River Mile 10.9 Removal Action – Steep Sloped Areas

PREPARED FOR: de maximis, inc.
COPY TO: File
PREPARED BY: CH2M HILL
DATE: September 26, 2013
PROJECT NUMBER: 474468.RA.PM.01

Attachment #1

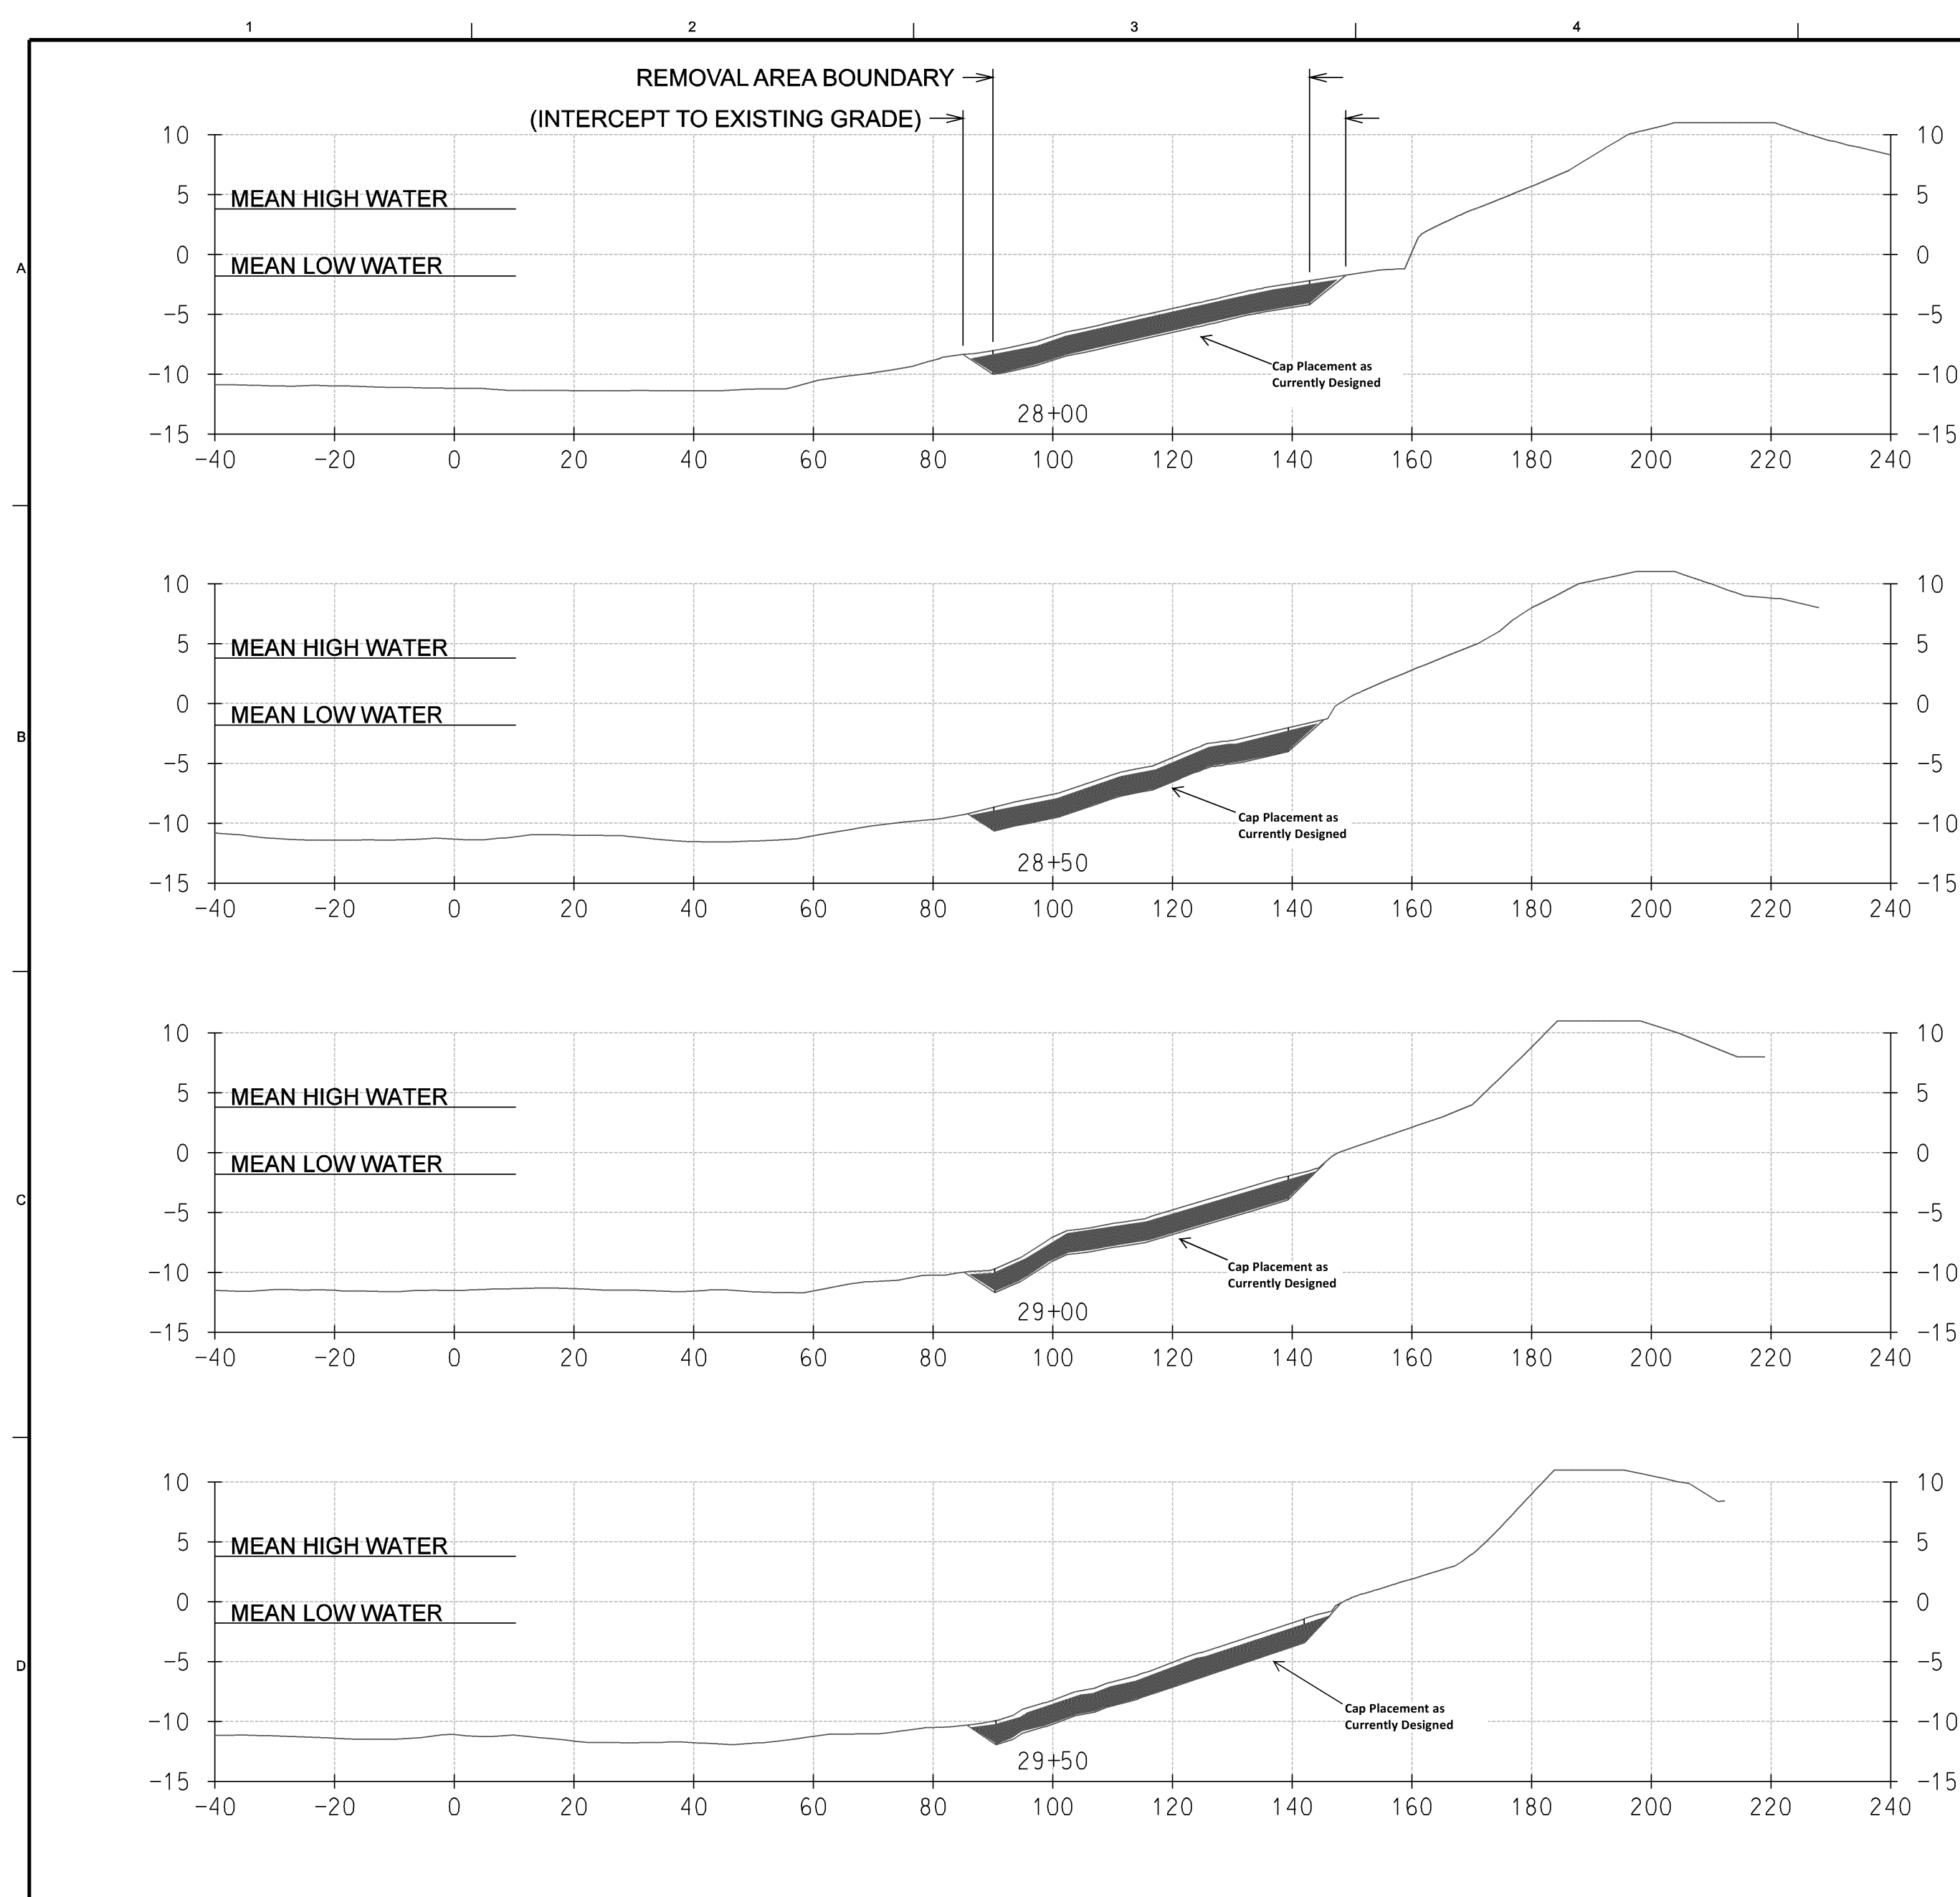
Approx Sta 31+00.

Where the water meets the rocks is the approximate edge of the cut.
